REPAIR AND ALTERATION FORM (AIRCRAFT, PROPELLERS, ENGINES, INSTRUMENTS)
 (SEE REVERSE SIDE OF THIS FORM FOR INSTRUCTIONS)

1. AIRCRAFT	MAKE Republic	MODEL RG 3	SERIAL NO. 477	NATIONALITY AND REGISTRATION MARK N6267K
2. OWNER	NAME (First, middle, last) Robert J. Zingheim			
	ADDRESS (Street and number, city, zone, and State) 4783 Voltaire St. San Diego 7, Calif.

7. DESCRIPTION OF WORK (ALL WORK MUST BE ACCOMPLISHED IN ACCORDANCE WITH PART 18 OF THE CIVIL AIR REGULATIONS AND ITS ASSOCIATED CIVIL AERONAUTICS MANUAL 18.)
Installed fairing aft. of rear spars, the entire length of ailerons and flaps, covering the large opening aft of spars and forward of control surfaces, to keep salt spray from entering the wings. The fairing is curved to conform to the aileron and flap action, leaving a 3/8 inch clearance between flap and aileron leading edge and fairing when control surfaces are moved in any position. Fairing is made of 24 ST .025 Alclad primed and painted. Fairing attached with PK screws, and 6 inch spacing. In test flight the aircraft had better maneuverability and increased the air speed 7 mph. Using same RPM and manifold pressure.

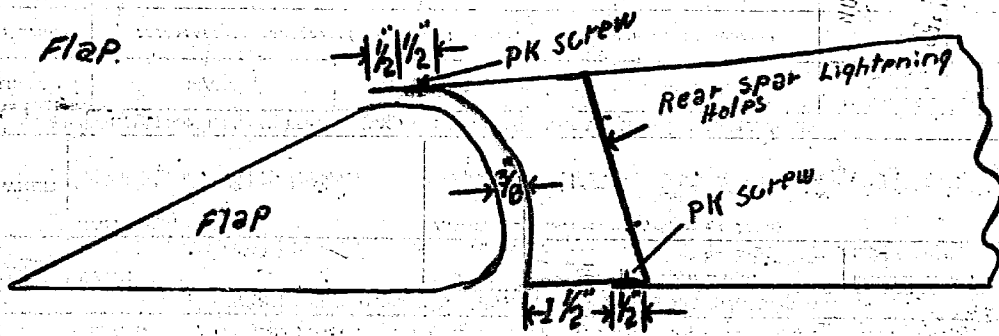
— New material 21ST.025 Alclad. NO 4 PK SCREWS USED.
 1 PK SCREWS # attachment for quick Removal During Inspection of wing Interior

<input checked="" type="checkbox"/> APPROVED <input type="checkbox"/> REJECTED	DESIGNEE'S SIGNATURE	NO.	DATE
	CAA AGENT SIGNATURE H. G. Stout 6479-10	<input type="checkbox"/> ACCEPTED <input type="checkbox"/> REINSPECTED	DATE Sept. 9, 1952
